CONSTRUCTION SUMMARY

Kingsmen (Thames) Inc. / Havelock Corners (Kingsmen)

Lot/Unit: 45 Phase/Building: 4B Model/Floor Plan: Spencer (4204) Elev C 4 Bed - 4+1 Bath

THAMES 4B: LOT 45
SKETCH #1

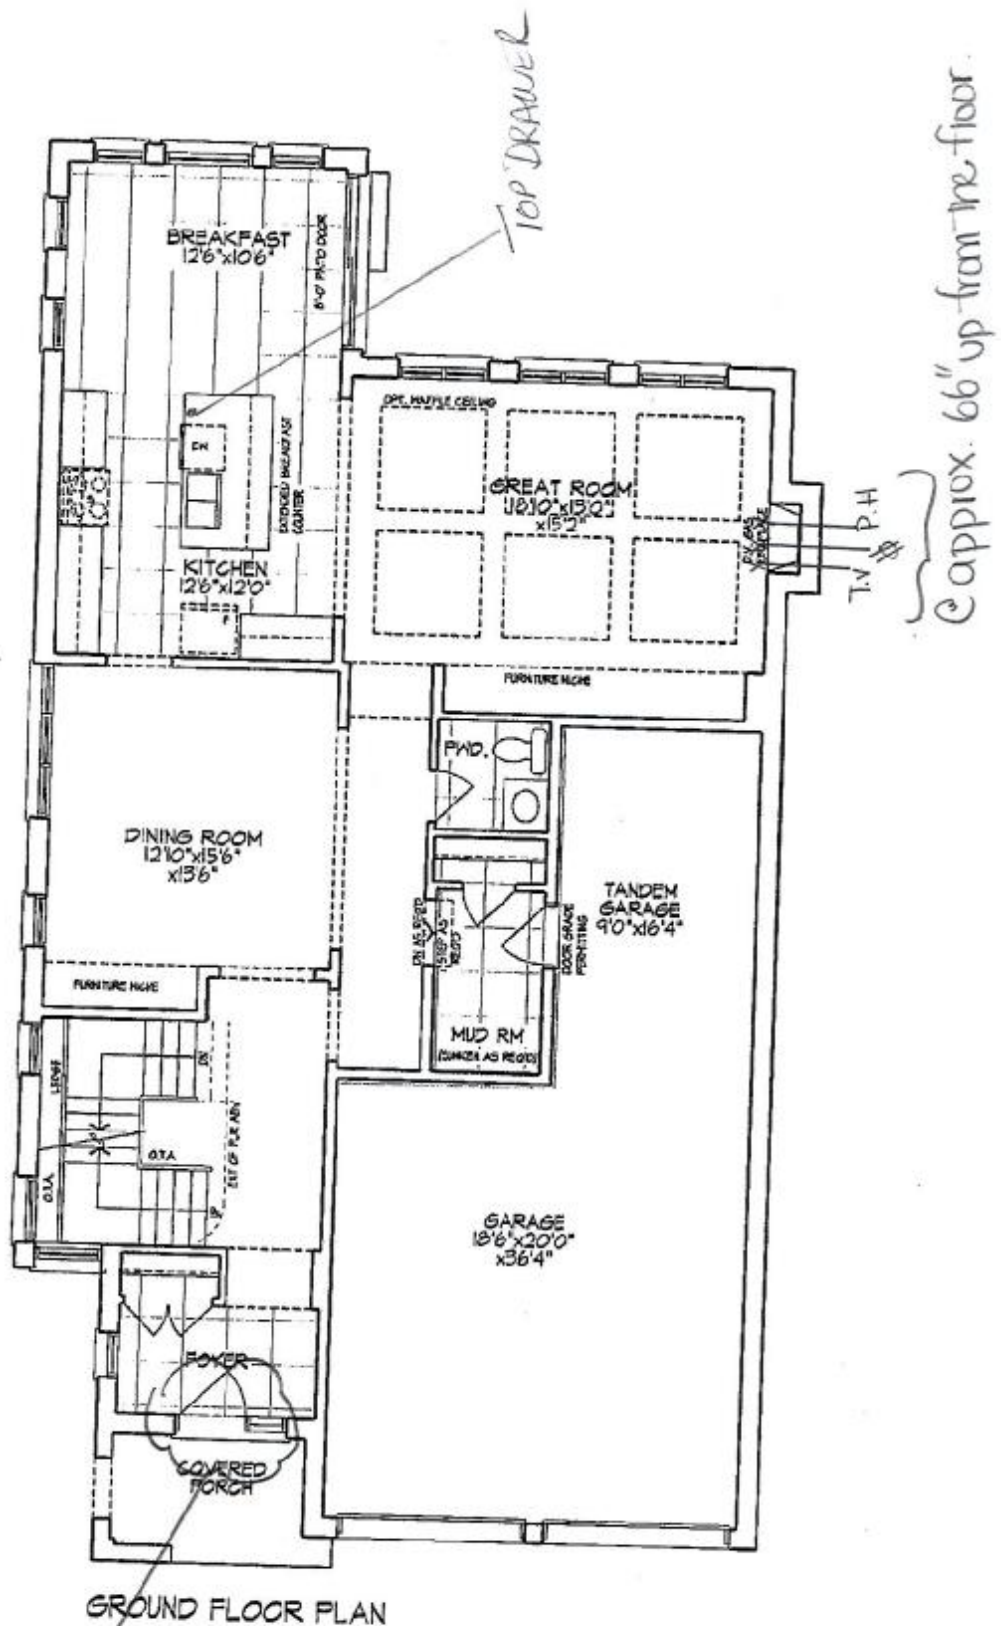
| Inv.4749 | 1 - To supply & install ONE TOP DRAWER in the kitchen.... see sketch # 1 | |

| Inv.4749 | 1 - As per Schedule "PE": Vendor to replace single door entry to home with a double door 8 feet tall, as per plan. See sketch #1. This will mean there will be no side lights and no transom on top of the front doors. | |

| Inv.4749 | 1 - To supply and install the standard T.V Rough-in, in the Great Room and Master Bedroom... see sketch #1 and #2 | |
| Inv.4749 | 1 - To supply and install the standard Phone (CAT 5) rough-in, in the Great Room, Master Bedroom and Media Niche.. see sketch #1 and #2 | |
| Inv.4749 | 1 - To SUPPLY AND INSTALL AN ADDITIONAL BASIC RECEPTACLE (NOT DEDICATED) centered +- over the F/P Mantle in the Great Room, at approx. 66" up from the floor.. see sketch #1 | |

Double Door without side
light transom or glass
8' High.

| Line 66866 | Note: TO SUPPLY THE T.V ROUGH-IN IN THE GREAT ROOM AT APPROX. 66" UP FROM THE FLOOR CENTERED ABOVE THE F/P MANTLE | |
| Line 66867 | Note: TO SUPPLY THE PHONE ROUGH-IN IN THE GREAT ROOM AT APPROX. 66" UP FROM THE FLOOR CENTERED ABOVE THE F/P MANTLE | |

THAMES 4B: LOT 45
SKETCH #2

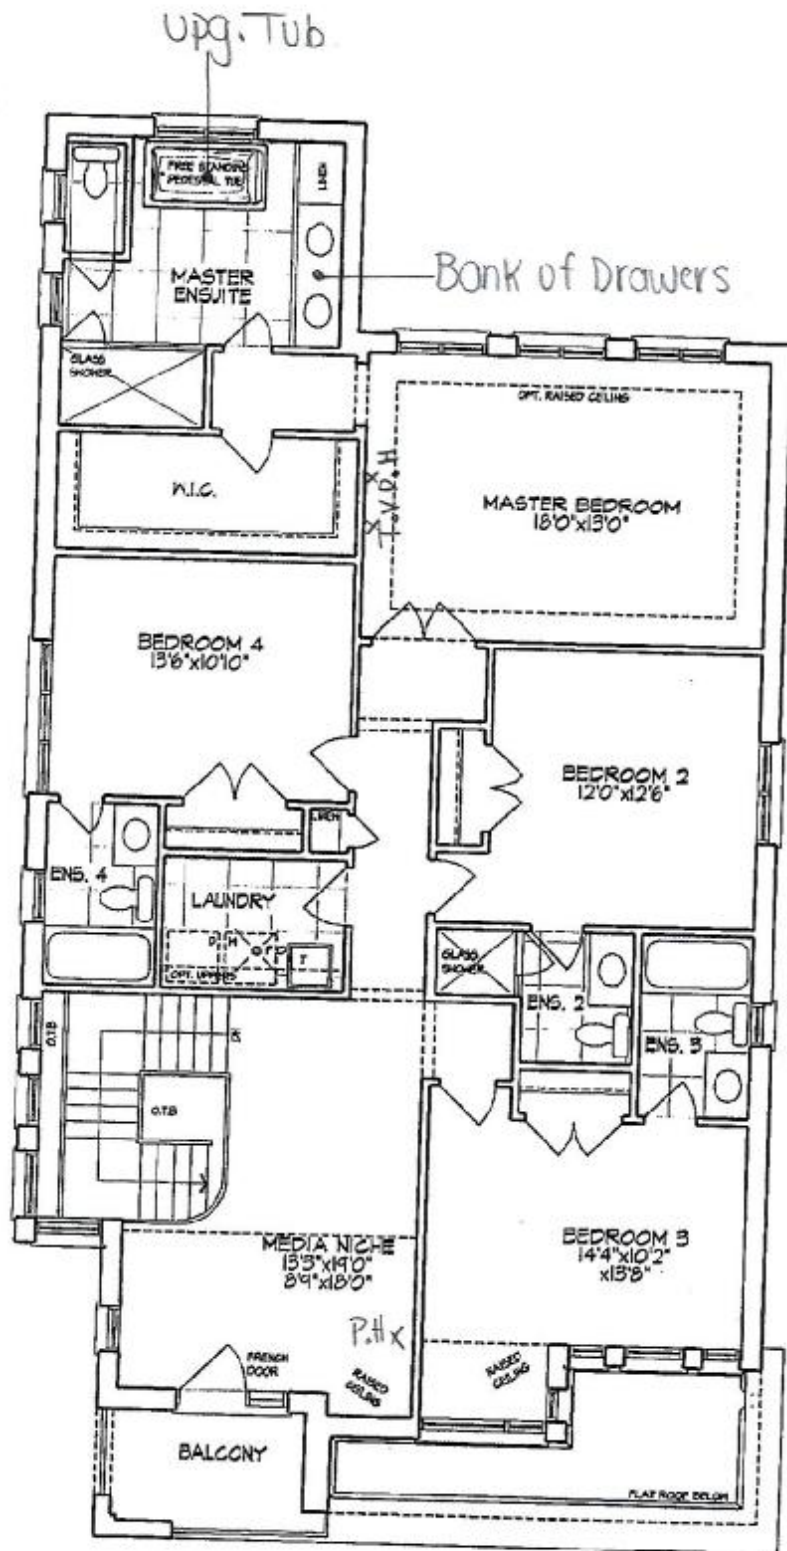
| Inv.4749 | 1 - To supply & install VANITY BANK OF DRAWERS - CLASSIC SERIES in the master ensuite.... see sketch # 2 | |

RE: UPG. SINK

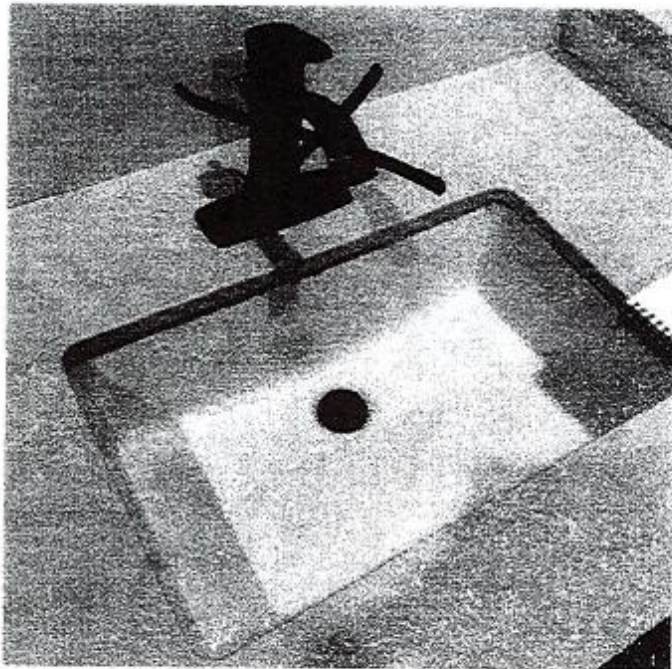
| Inv.4749 | 1 - To supply and install the VANITY SINK - CONTRAC CATENA UNDERMOUNT - MODEL 4210CIY in PWD ROOM ONLY in lieu of the standard sink.. see spec's | |

Contrac Catena Undermount
Model 4210CIY

| Line 66869 | Note: Still to install the standard lav. faucet. | |

Free Standing Tub

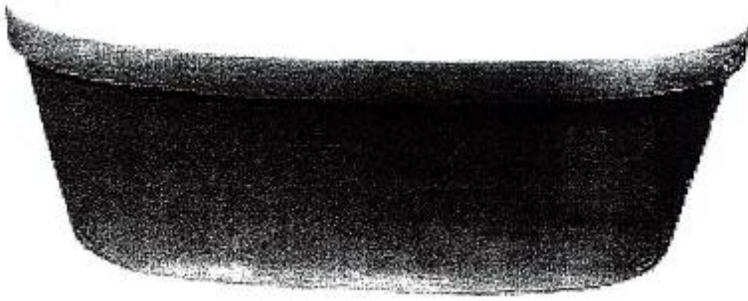
| Inv.4749 | 1 - To supply and install the mirlion brooke free standing tub in the Master Ensuite in lieu of the standard free standing tub.. see spec's | |

Mirolin Brooke CF2002
68x36x23
